SERVICE NO. 1242A BULLETIN

Date: May 12, 2020

RUDDER PEDAL ASSEMBLY INSPECTION

SB 1242A adds additional inspection locations in Part II. Other changes update the document to the current Piper format.

Figure 1
Rudder Pedal Installation (Typical)

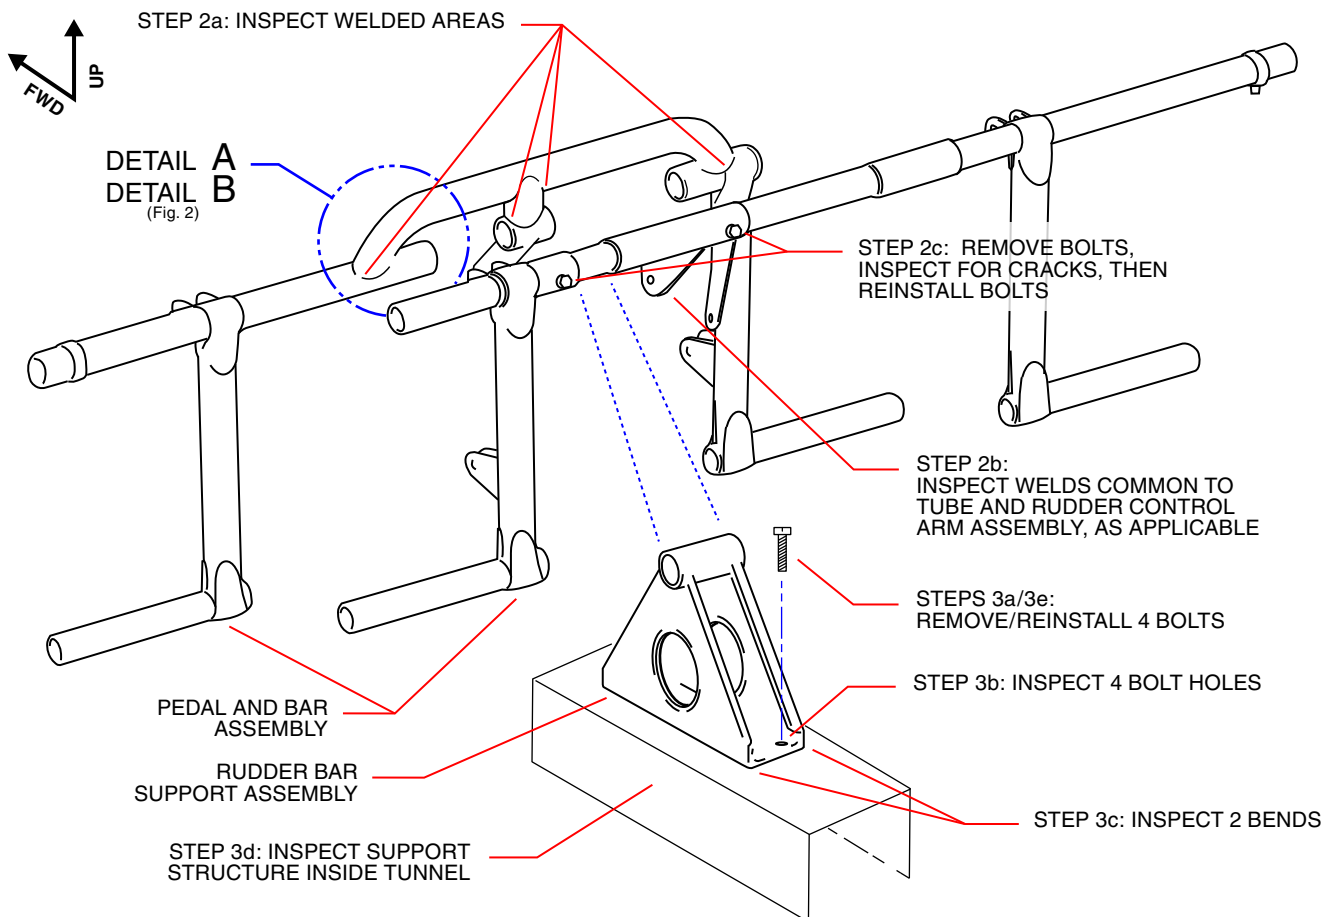
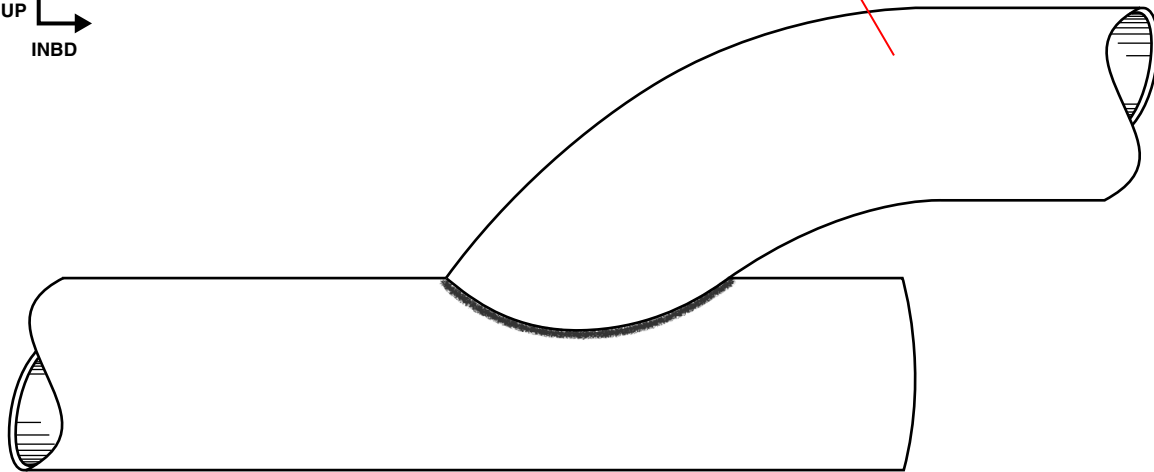
1. Gain access to the areas identified in Figure 1.

Visually inspect the rudder pedal and bar assembly (locations identified in Figure 1), with specific emphasis on:

- b. Visually inspect the four (4) bolt holes for cracks and elongation. See Figure 1. The diameter of the four bolt holes should measure $0.250 +0.005/-0.001$ inches.
- c. Visually inspect the two (2) sheet metal bends common to the base for cracking, the entire length of each bend, both inner and outer surfaces. See Figure 1.
- d. Visually inspect the support structure for cracks or other damage. The support structure is located under the top surface of the tunnel, directly below the rudder bar support assembly.
- e. Reinstall the four (4) bolts that secure the rudder bar support assembly to the cockpit floor.

Figure 2
Rudder Bar Welding (Typical)

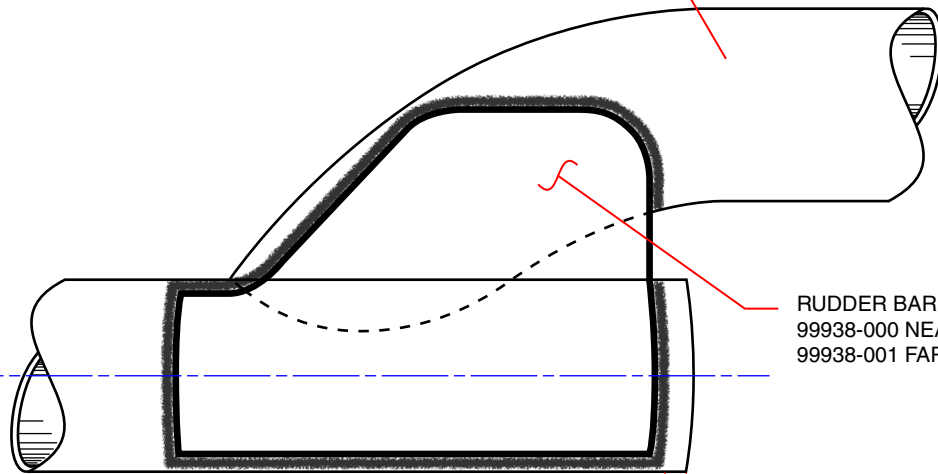
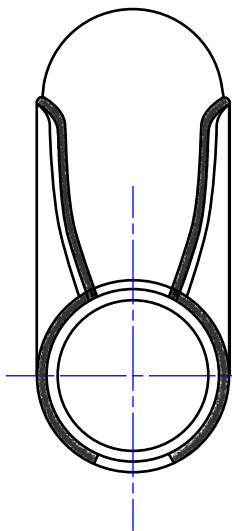
- Examine the area identified in Figures 1 and 2 to determine which rudder bar assembly configuration is installed on the airplane.
 - If the rudder bar assembly conforms to Figure 2, Detail B, the airplane is already in compliance with Service Letter (SL) 671, and/or a replacement rudder bar assembly has been installed which includes these features. No modification is required. Proceed to Part II.
 - If the rudder bar assembly conforms to Figure 2, Detail A, modification is required. Proceed to Step 2, below.

- a. Welds identified in Details A and B (see Figure 2).
- b. Welds common to the tube and the rudder control arm assembly, as applicable.
- c. Bolt holes: remove the bolts that fasten the left and right pedal assemblies to each pedal and bar assembly. Using a borescope or other suitable tool, visually inspect the bolt hole in both inner and outer tubes for cracks. Reinstall bolts.

3. Examine the area to be modified for cracks, using the inspection criteria described in Part II. Any cracked components must be replaced prior to proceeding.
4. Order one each of Piper part numbers (P/N) 99938-000 and 99938-001 rudder bar straps. TIG weld in place as shown in Detail B, per Chapter 4 of AC 43.13-1B (or latest revision). After welding, relieve residual stress in the affected area: Heat with a non-carburizing torch flame to 1,000 – 1,100 °F (538 – 593 °C) (a brown red color) then air cool to room temperature. All welding must be performed by a certified welder.

- All materials are 4130 normalized steel.
- The rudder bar tubes have a nominal outside diameter of 0.875 inches and nominal wall thickness of 0.058 inches.
- P/N 99938-000 and 99938-001 rudder bar straps are made from sheet steel with a nominal thickness of 0.040 inches.

RUDDER BAR STRAPS:
99938-000 NEAR SIDE
99938-001 FAR SIDE
